Proposed Residential Development The Old Stable Yard, Winthorpe Road, Newark

Technical Review

**For:
Newark and Sherwood District Council**

Ref: NIA-10951-23-11131-v1 Winthorpe Road, Newark
Issue: Final
Author: T. Crabb BSc (Hons) MIOA

Figure 1.2: DEFRA Daytime Road Traffic Noise Levels

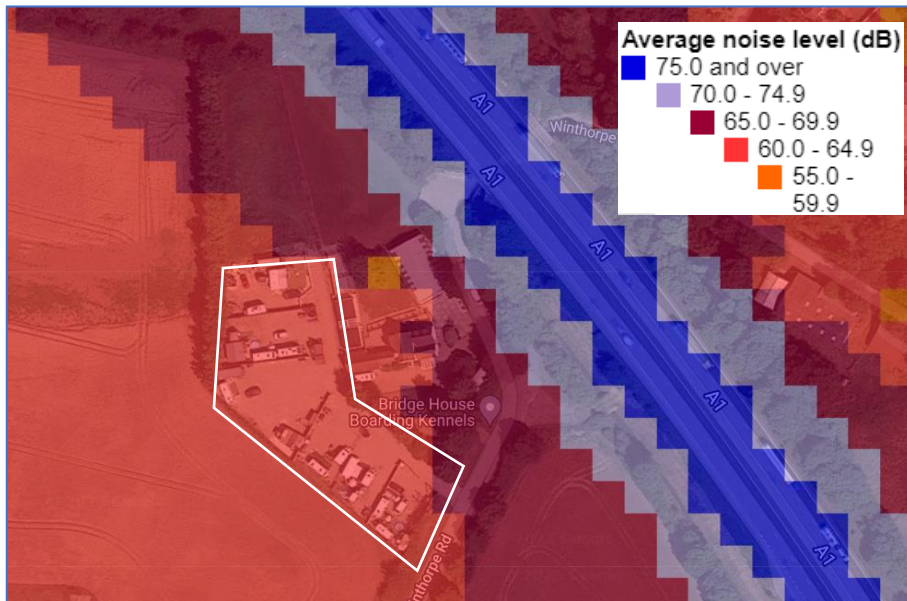
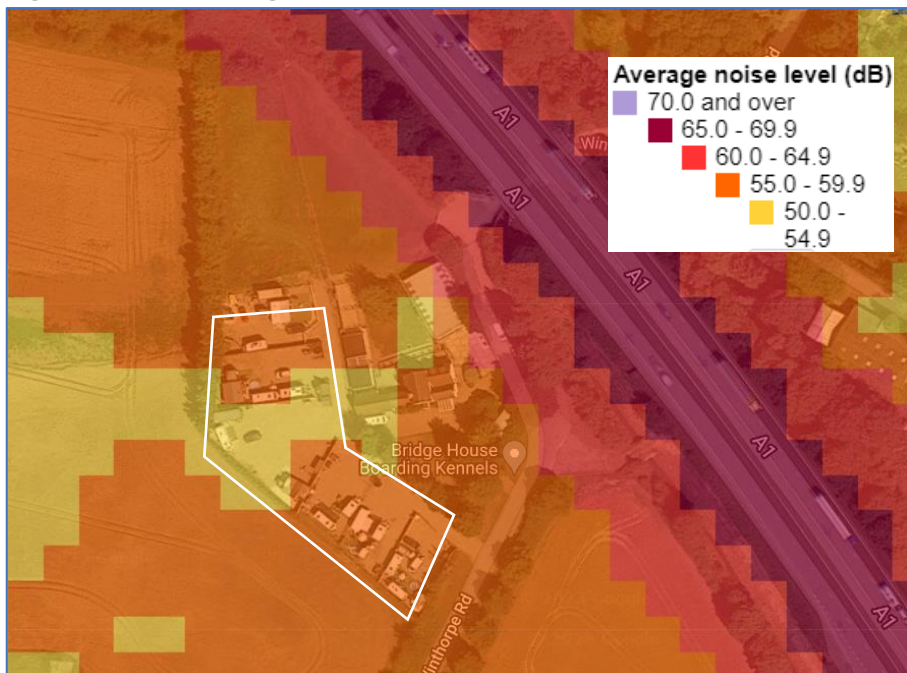
The measured daytime level at Position 1 (**64 dB L_{Aeq} (0700-2300)**) also correlates closely with the noise levels produced by Defra (circa **65 dB L_{Aeq} (0700-2300)** at the northern site boundary).

It is evident that the levels measured during the baseline survey are representative.

Figure 1.4: Proposed Route of A46 Newark Bypass

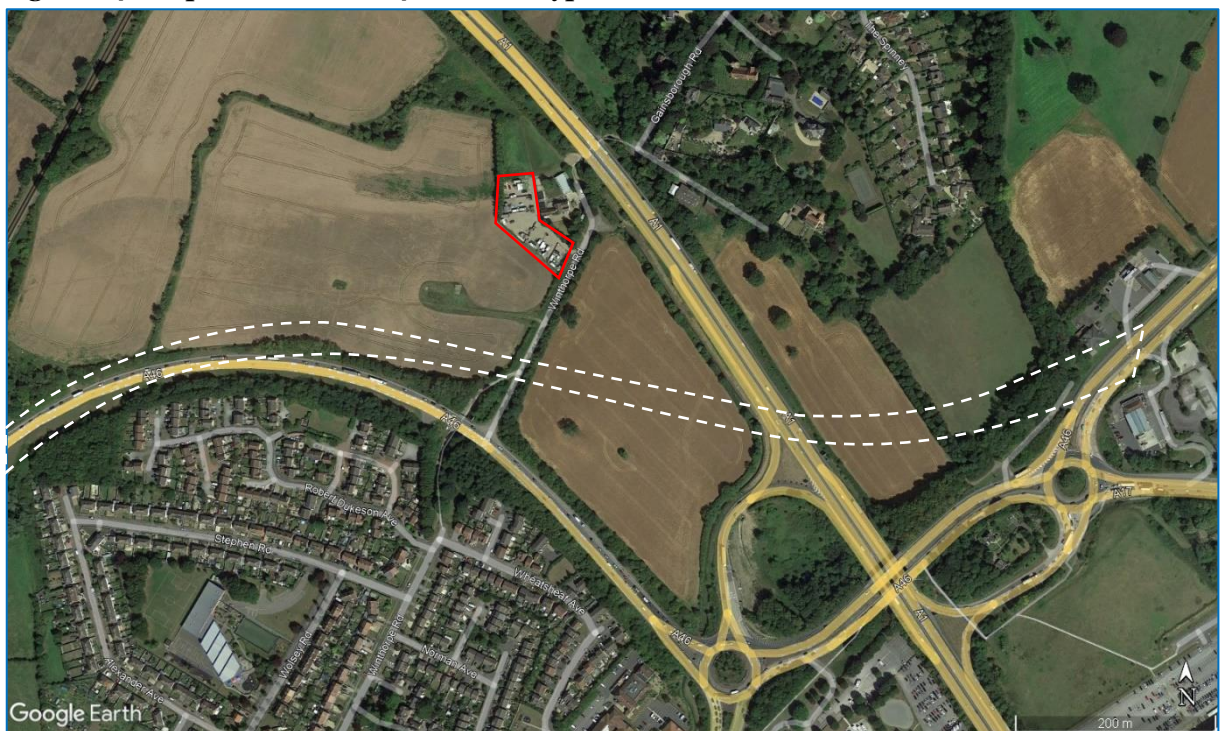
The inspector also notes that no consideration has been given to the noise impacts of the proposed expansion and re-routing of the A46.

With respect to the A46 Newark Bypass, it is noted that the planned route will reduce the separation distance between the A46 and the site from circa 175 metres to circa 90 metres.

Preliminary noise level predictions provided by the contractor indicate daytime and night-time ambient noise levels of **66 dB LAeq (0700-2300)** and **58 dB LAeq (2300-0700)** respectively at Position 1, and **65 dB LAeq (0700-2300)** and **56 dB LAeq (2300-0700)** respectively at Position 2. This indicates that the A1 is still the dominant noise source at both positions.

Daytime noise levels are 2 dB higher than the levels measured within the NIA, and 1 dB higher than the noise levels produced by Defra. Whilst it should be confirmed whether the increase is due to greater contribution from the realigned A46 or variations in the modelling of noise from the A1, it should be noted that the change in noise levels is not significant and would be unlikely to alter the conclusions.

Figure 3.1: ProPG Initial Site Noise Risk Assessment

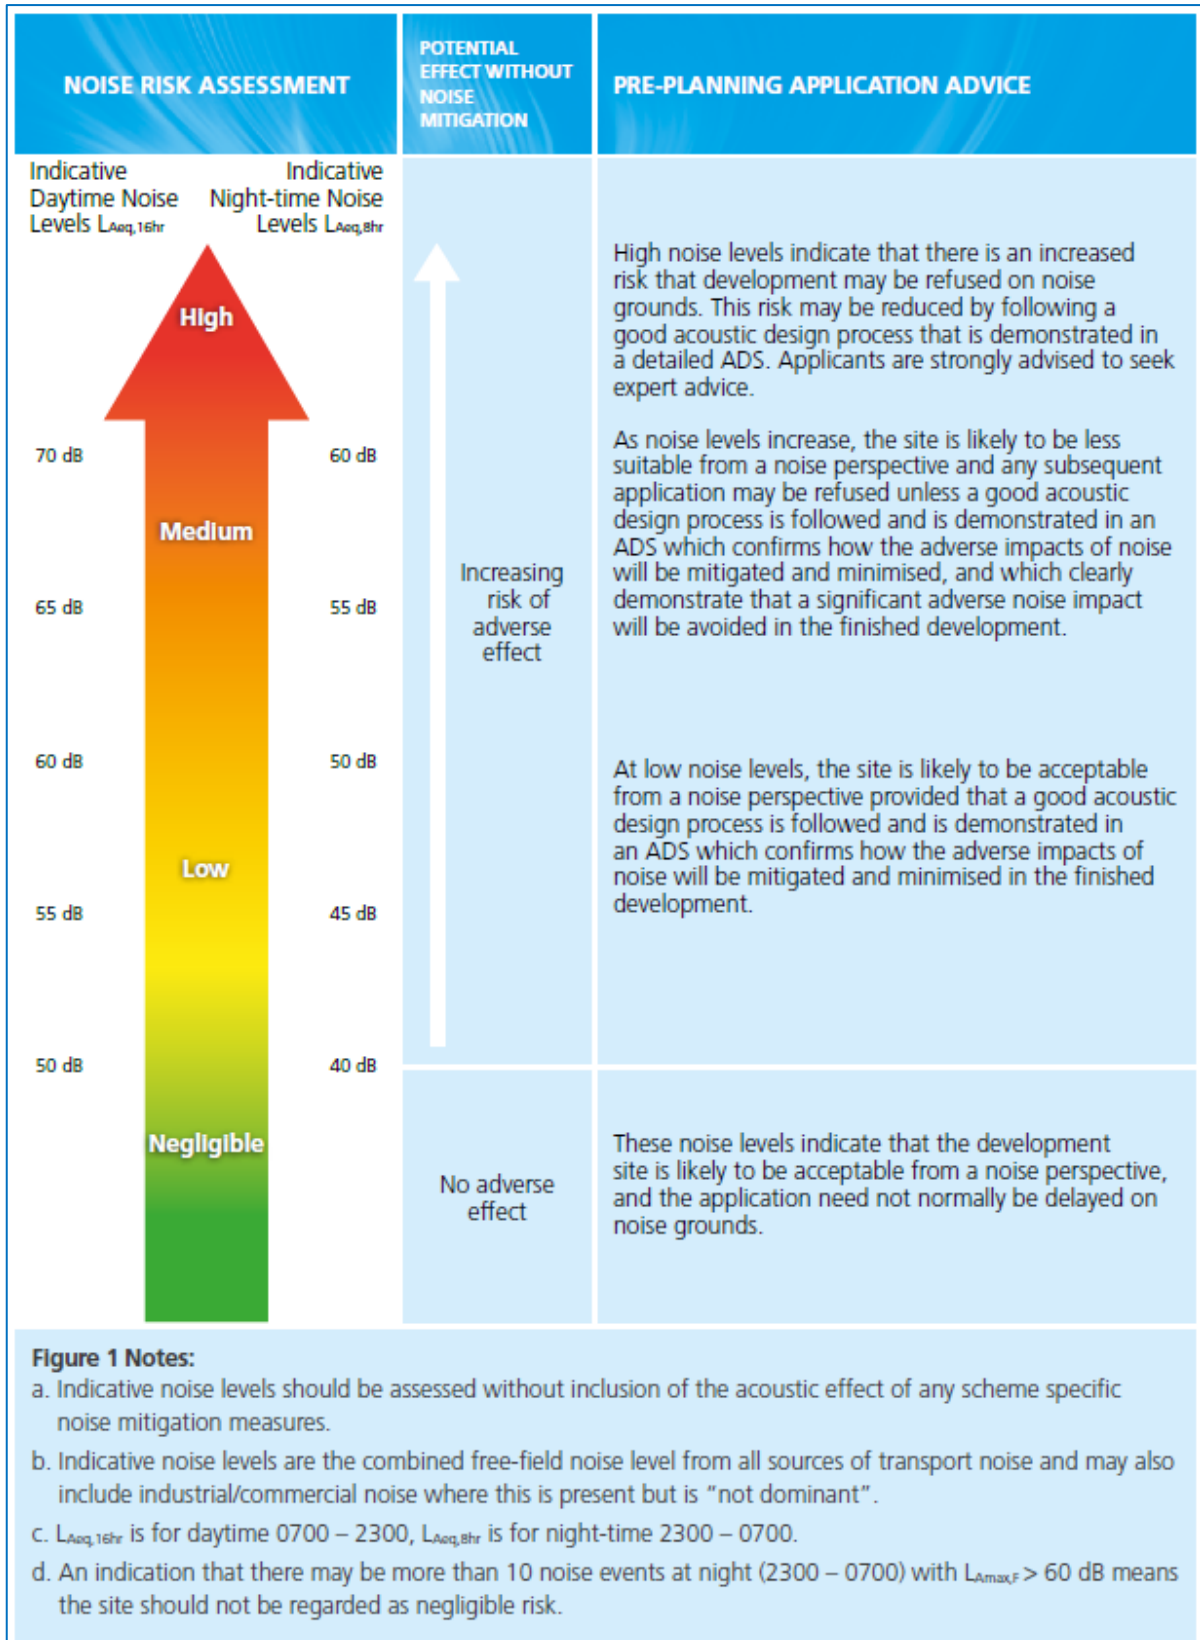
Point 6 of the response states that ProPG has been selectively quoted, and that the report does not address ‘good acoustic design’.

Stage 1 of ProPG consists of an initial noise risk assessment, as summarised in Figure 1 of ProPG (reproduced overleaf for reference). To put the noise levels at the site in context, with the provision of the proposed screening, the site would constitute a ‘medium’ risk in terms of ProPG.

In summary, due to the nature of the site and development, the options for implementing ‘good acoustic design’ are limited.
